DELEGATED APPLICATION REPORT

App Ref: PL/24/1234 Full planning permission

Address: Station Hill Reading Friars Walk, Friars Walk, Reading, RG1 1DX

Proposal: Installation of Four Art Works across Station Hill including, Mosaic Mural at Station Underpass Wall, Mosaic Mural at Friars Walk, and two sculptures "The Seed" and "Pivotal" at Station Square.

“Pivotal” Sculpture

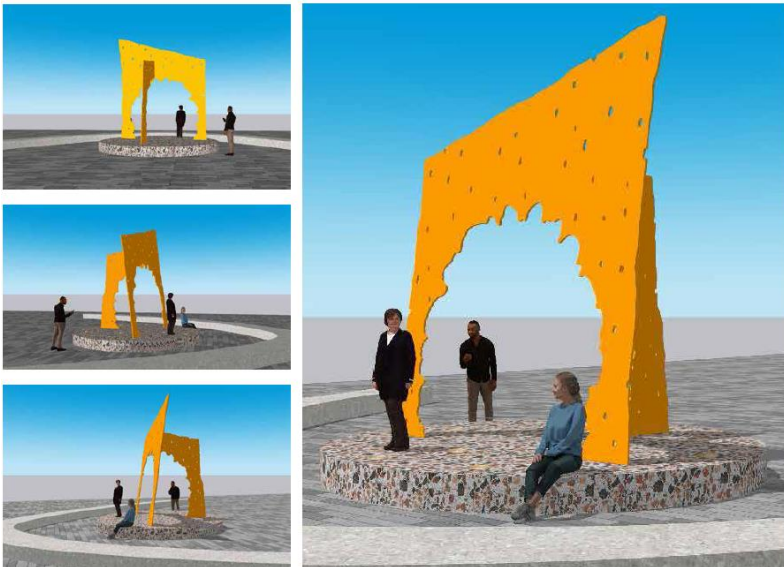
The Pivotal sculpture, by artist Neon would be located to the front (north) of the Plot G office “One Station Square”, fronting onto the Pocket Park open space. The proposal is described as a “monumental

flag inspired kinetic artwork". The proposal would be approx. 11 metres tall and would comprise a series of metal fins which each move independently in the wind and can be lit at night.

The proposal would be a striking addition to the space and would provide a focal point at the entrance to the office and the steps to the park. Although tall, it would not be unduly prominent in the context of the very large office buildings which lie adjacent. The proposal would not affect or harm the setting of the listed railway station building or the Edward VII statue.
